In the Matter of
PACIFIC GAS AND ELECTRIC COMPANY
(Diablo Canyon Nuclear Power Plant, Units 1 and 2)
Docket Nos. 50-275 OL and 50-323 OL

SUBJECT: DIABLO CANYON TUBE STEEL DESIGN VERIFICATION

MEMORANDUM FOR: D. Kirsch, Chief, Reactor Projects Branch *K*
FROM: B. Wagner, Reactor Inspector
THRU: H. Canter, Chief, Engineering Section
SUBJECT: TUBE STEEL RADII MEASUREMENTS
re: DCAF Allegations 92/93

SUBJECT: TUBE STEEL RADII MEASUREMENTS

Tangential Gaging Method

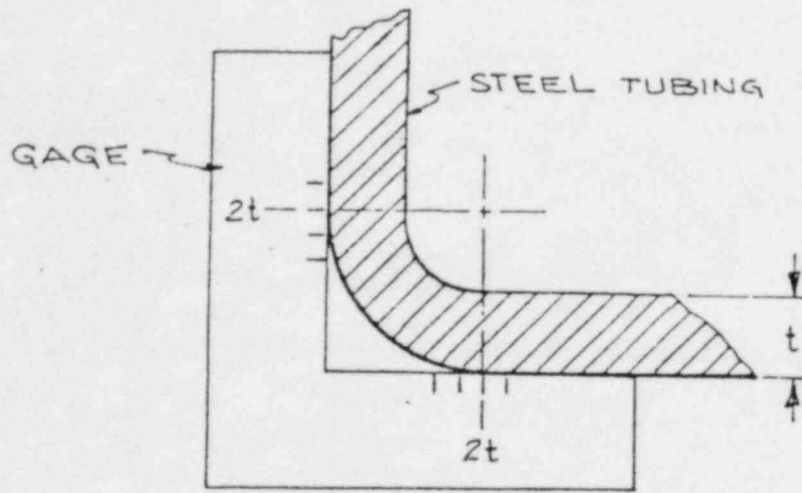
2.0 The method of measurement described in paragraph 2 and illustrated in Figure 1 apparently requires additional explanation. The initial instructions (reference 1) did not include a preferred method of measurement and the method employed by the licensee for the data presented in reference 2 was not described. In addition, the American Tube Manufacturers Institute specification referenced by the licensee (reference 2) to establish the relationships between tube wall thickness, t , and the corner radius of curvature, R , could not be found. As a consequence, the licensee was asked to fabricate gages for the inspectors to perform an initial check of the tube corners to be followed

by the tangential measurements shown in Figure 1 (reference 3) in the event irregularities were encountered. The gages requested were to be similar to the one shown in Figure A2. Figure A1 shows what was provided and used since the schedule would not accommodate a delay for making more gages. Once the field work was underway it was evident that the majority of the material had corner irregularities and that the gaging step offered only qualitative results. Therefore, all of the tubing was examined using the tangential method to produce quantitative data suitable for almost any subsequent evaluation required by the staff.

3.0 The second sentence of paragraph 2 under Inspection Results should be amended by replacing the words "wall thickness" by the word radius. The radius of curvature is defined as the minimum value of R measured as shown in Figure 1. In addition minor revisions to the summarized results are necessary to account for the data revisions described below.

Figure A1

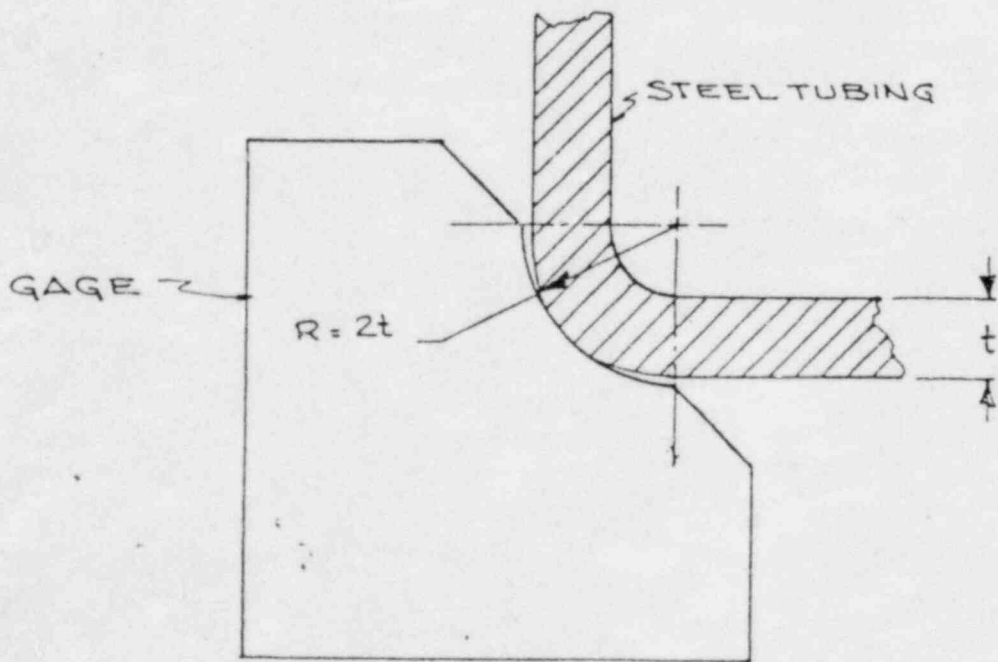
5.0 Items R30, J58, J66, J69, J71, J80, and J84 in Attachment 1 were reinspected by a different inspector during the week of May 28, 1984, using the gage illustrated in Figure A2. The measurements taken verified the initial data.
